REQUEST FOR TENDER RFT #B24-02

Washroom Upgrades

ADDENDUM NO. 6

- 2.1 This addendum applies to the **Gravenhurst High School** project only.

ADD 6.1 PRIVACY SCREEN

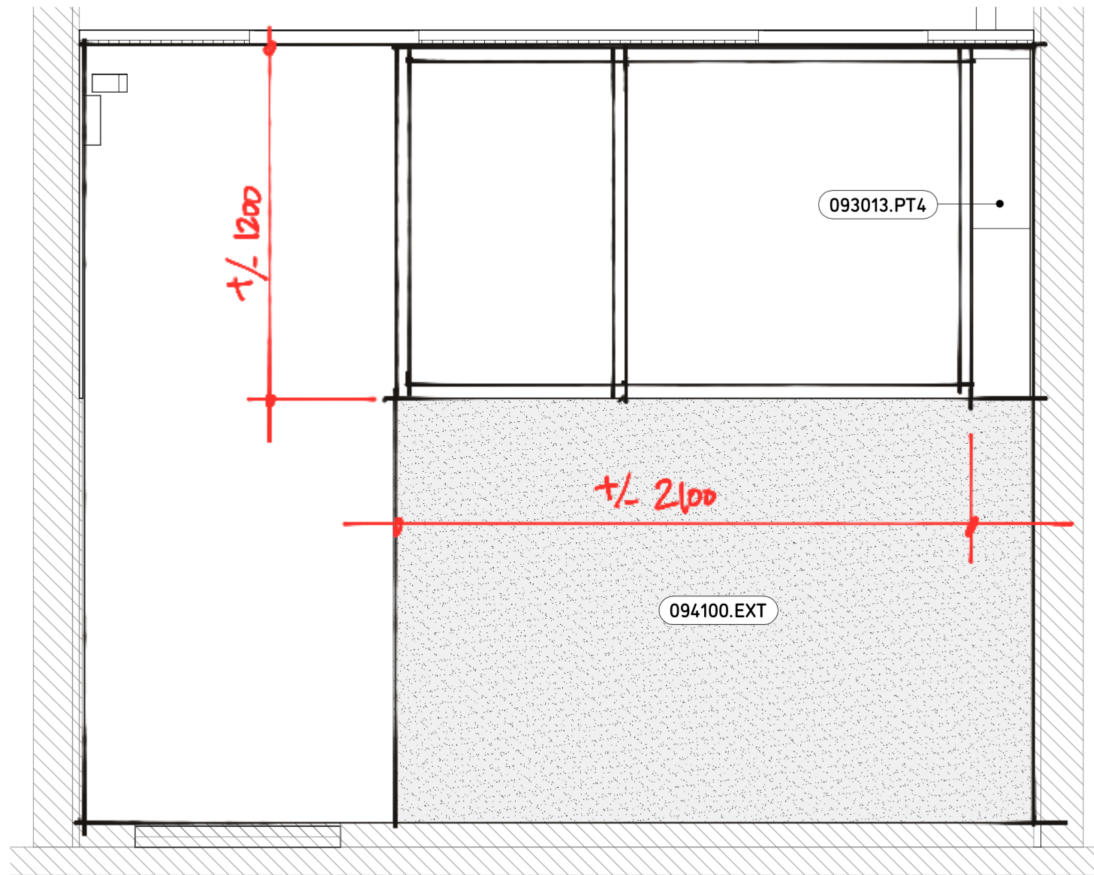
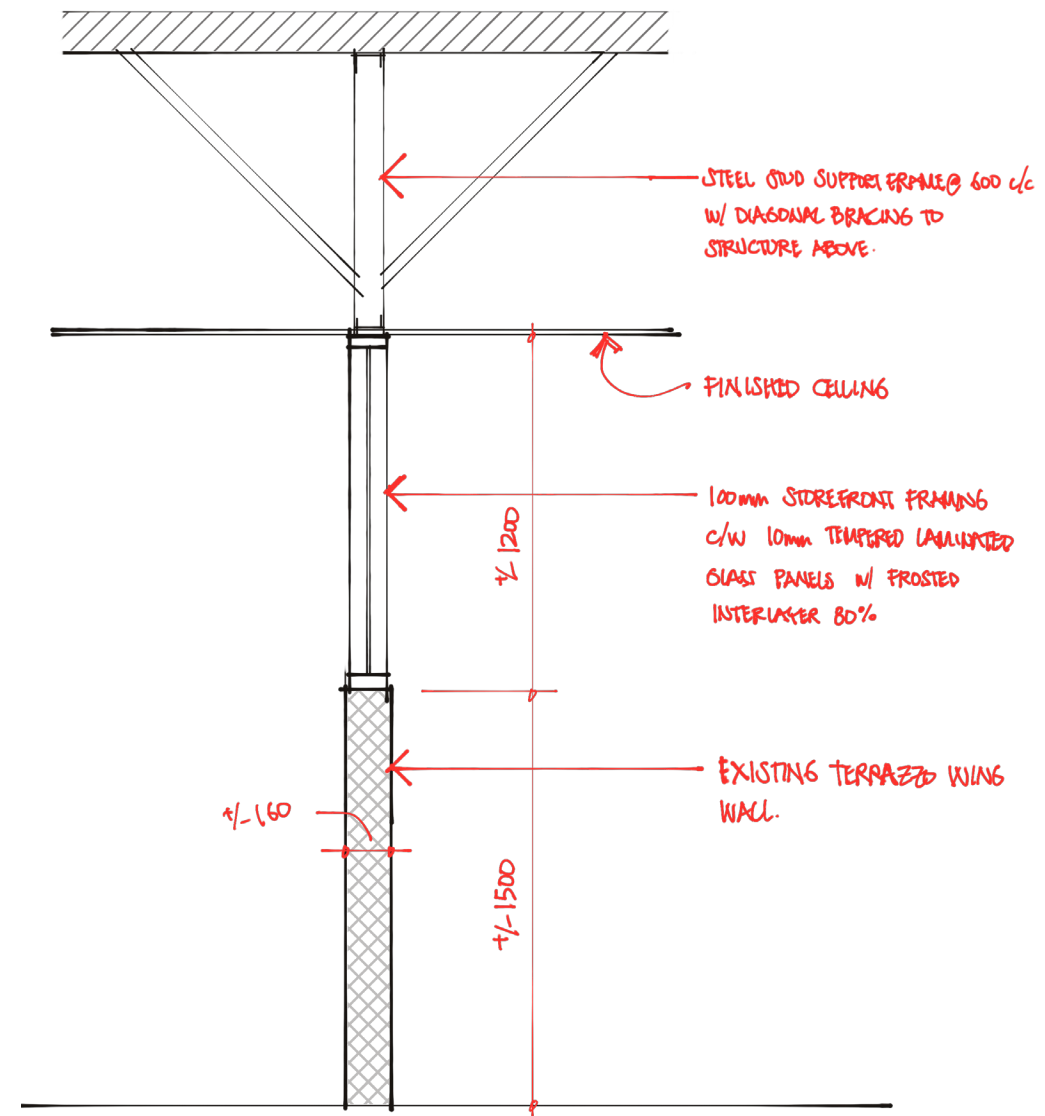
- 3.1 **ADD:** Typical at all WF-1 wash fountains installed on existing concrete block walls provide vertical trenching detail 2/DSK 04.1 for new water supply, venting and power supplies to new WF-1.
- 3.2 **ADD:** Unit price: Storefront privacy screen.

Bidders are to include a unit price for a storefront privacy screen as indicated on the attached sketch **ADD 6.1** as a separate line item in their schedule of values. The privacy screen is to be installed on top of the existing terrazzo wing wall at the entrance to each washroom. For the purposes of bidding only one privacy screen is to be included in the bid price as a unit price to be used at the Owner's discretion to include in the project at one or up to four of the washroom locations in the project.

Unit price to include supply and installation of:

- Clear anodized storefront framing system
- Tempered laminated glazing (10mm)
- Above ceiling steel stud bracing assembly.
- Two additional F1 light fixtures that will be required to accommodate the new privacy screen.

Carry the price for one washroom (Rm 120) in the bid price that could be applied to one or up to four washrooms using a similar design.

ALUMICOR FLUSHGLAZE TL1800 OR SIMILAR
 44.5mm x 114.3mm FRAME PROFILE
 CLEAR ANODIZED
 10mm TEMPERED LAMINATED GLAZING C/W FROSTED
 INTERLAYER (80% OPACITY)
